### PLANNING COMMISSION AGENDA

**Thursday, June 18, 2020**

3.3. Request: Preliminary Plat approval for Mountain Ridge Phases 1-2, including 94

# Mountain Ridge Engineering DRC Comments June 2, 2020

### **Engineering Comments**

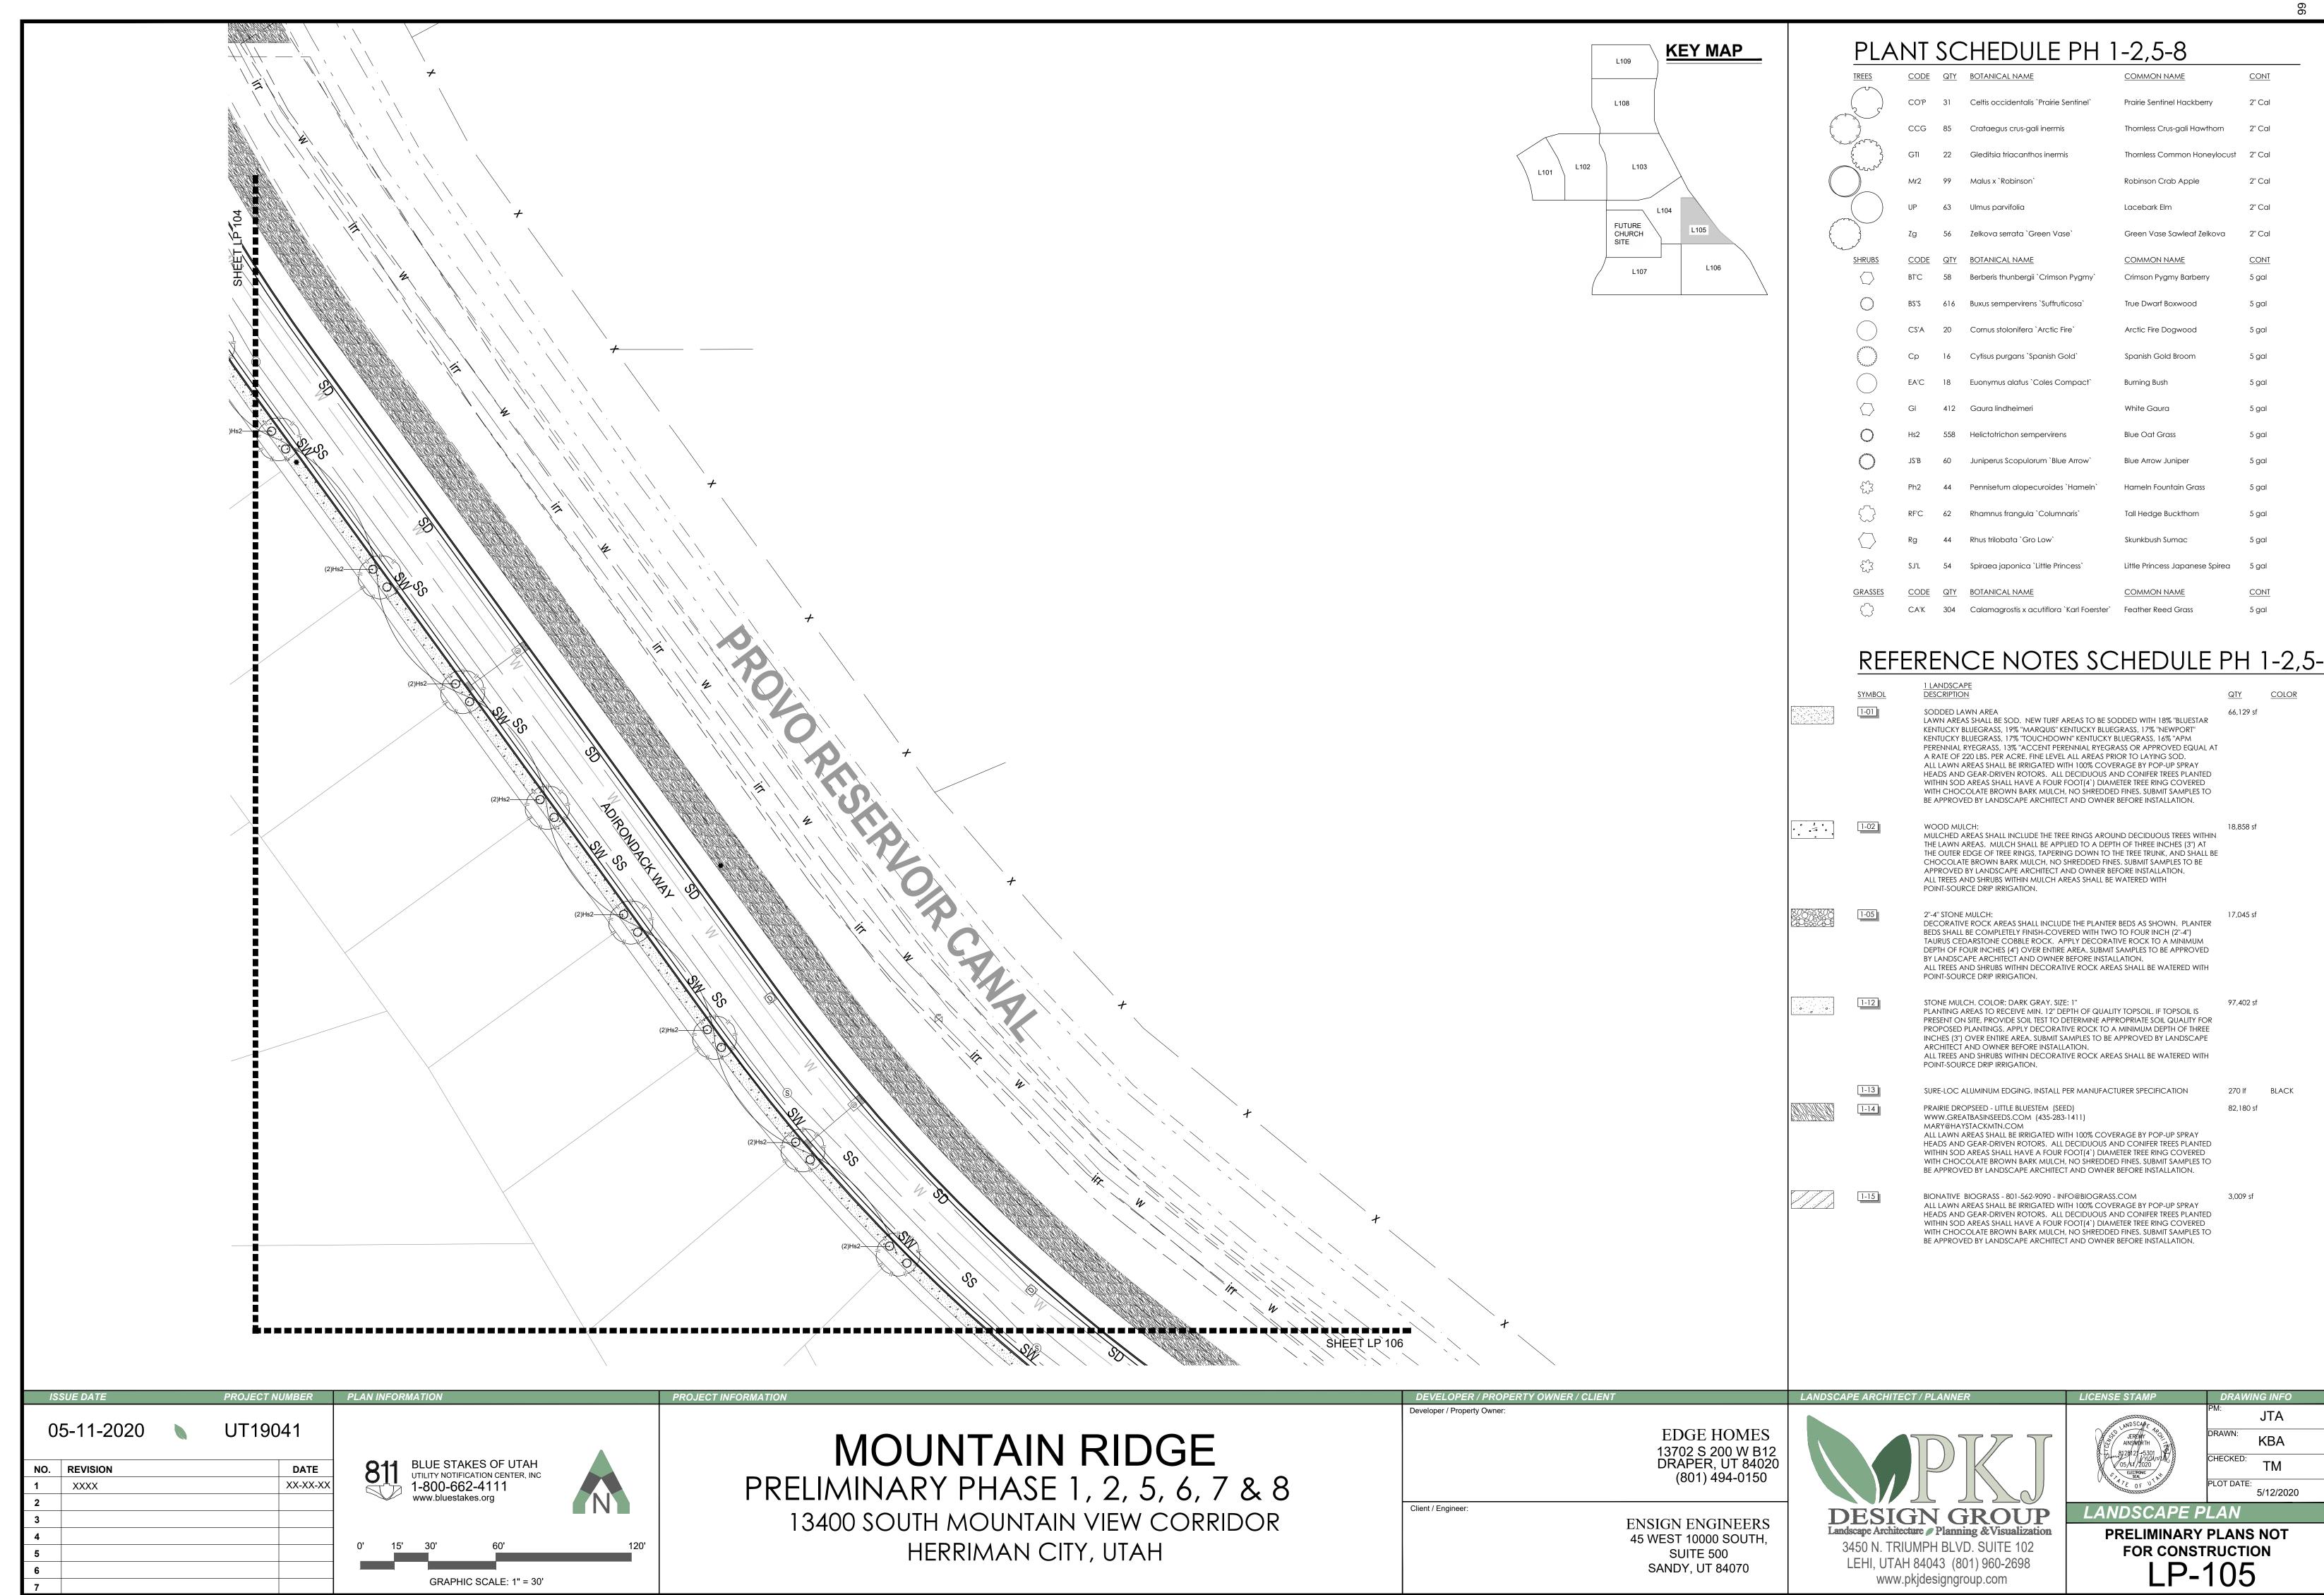
- Show locations of fire hydrants on utility plans.
- Temporary turnaround may be required between phase 7 and 8 depending on timing.
- Private drives and alleys will need to be signed no parking on both sides due to width.
  - o Entrances and 150' intervals.
- Provide road cross sections details.

- Improvements to all public streets to include sidewalk, curb and gutter, landscaped parkstrips to city standards, and city standard lighting.
- Show all road cross sections.

- Include civil details including road improvements, trails, etc.
- Project will need a development drainage master plan for the entire development for review.

- Will ditch be piped in future.
- How will 10 acre park be developed in multi phased approach for detention.
- Include nuisance by-pass piping to prevent muddy bottom in 10 acre park.

- NOI required.
